ADDENDUM NO. 1

CORTLAND COUNTY HIGHWAY DEPARTMENT

CORTLAND COUNTY LANDFILL
GAS COLLECTION AND CONVEYANCE SYSTEM

CONTRACT NO. 1A – GENERAL CONSTRUCTION

2 TYPICAL PASSIVE FLARE ABANDONMENT DETAIL

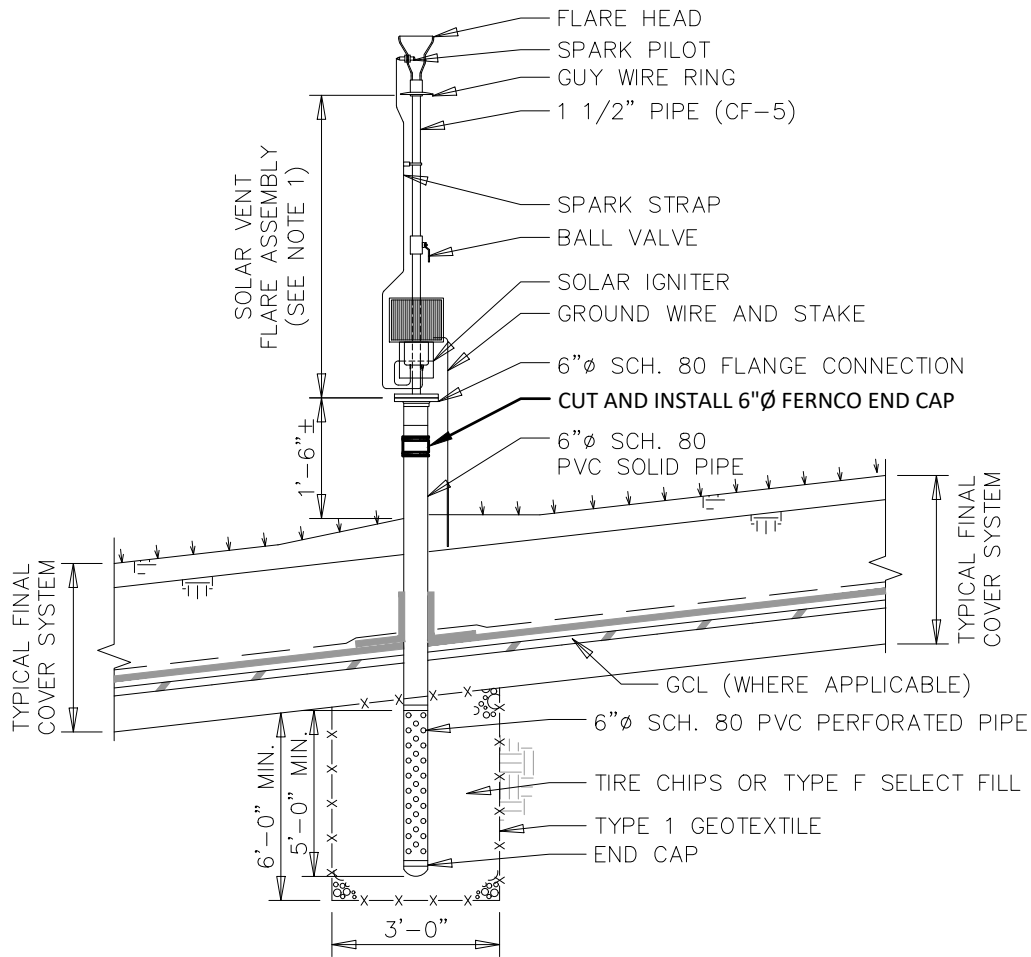
6. Reference: CONTRACT DRAWINGS – SHEET C504- CLOSURE AREA LFG DETAILS
 - a. DETAIL 2 – TYPICAL PASSIVE FLARE ABANDONMENT DETAIL, DELETE in its entirety and SUBSTITUTE THEREFOR SK-1 as attached to this Addendum No.1.

1. COMPONENTS OF FLARE REMOVED SHALL BE SALVAGED AND RETURNED TO OWNER.
2. LOCATIONS SHOWN ON SHEET C400.

4 TYPICAL GAS VENT ABANDONMENT DETAIL
 NOT TO SCALE

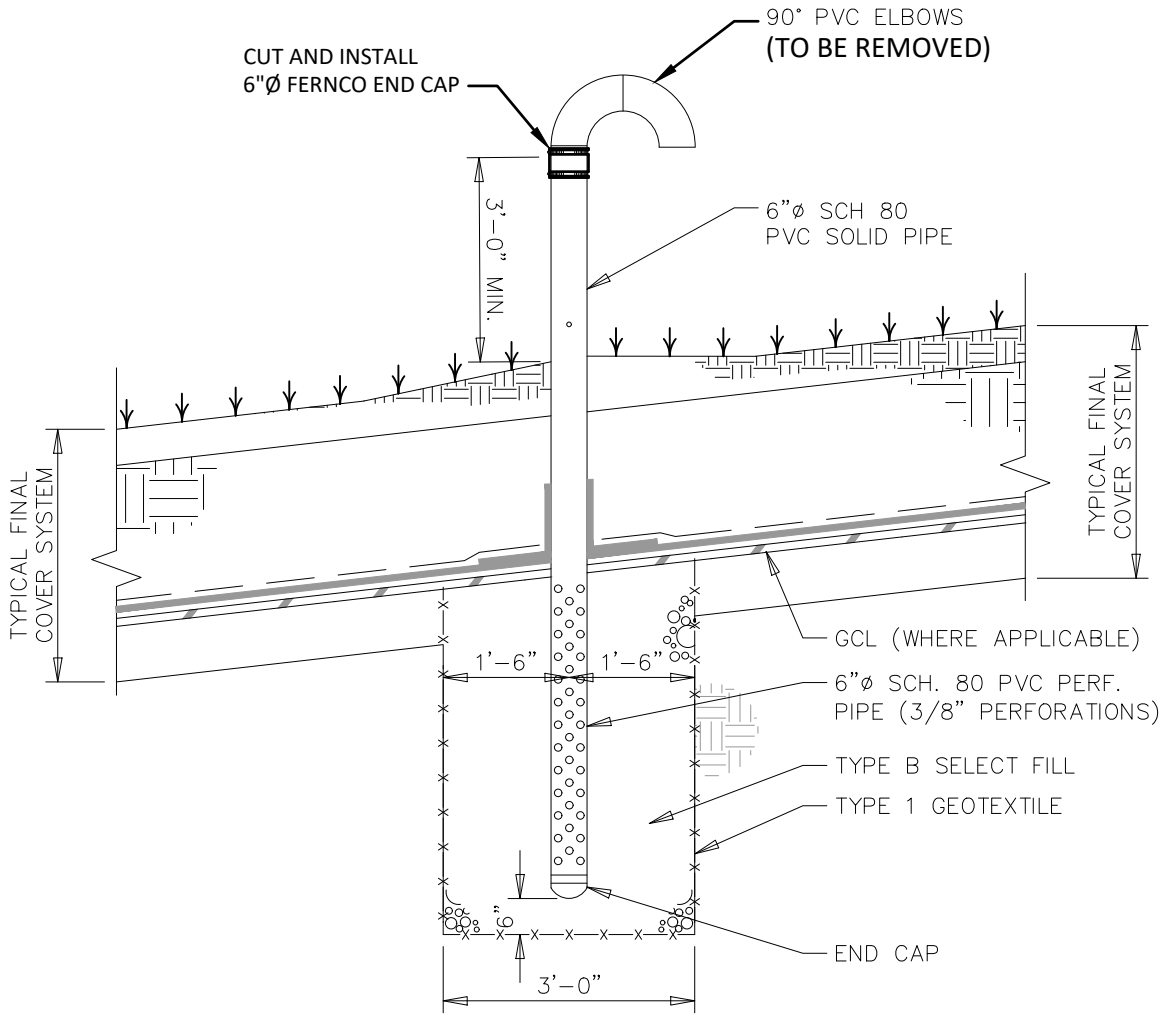
- b. DETAIL 4 – TYPICAL GAS VENT ABANDONMENT DETAIL, DELETE in its entirety and SUBSTITUTE THEREFOR SK-2 as attached to this Addendum No. 1.
7. Reference: CONTRACT DRAWINGS – SHEET E505 – CONDENSATE CONVEYANCE DETAILS

1. LOCATIONS SHOWN ON SHEET C400.
2. GAS VENTS TO BE ABANDONED SHALL REMAIN UNMODIFIED UNTIL LANDFILL GAS FLARE IS OPERATIONAL. GAS VENTS TO BE ABANDONED AT THE DIRECTION OF THE ENGINEER.
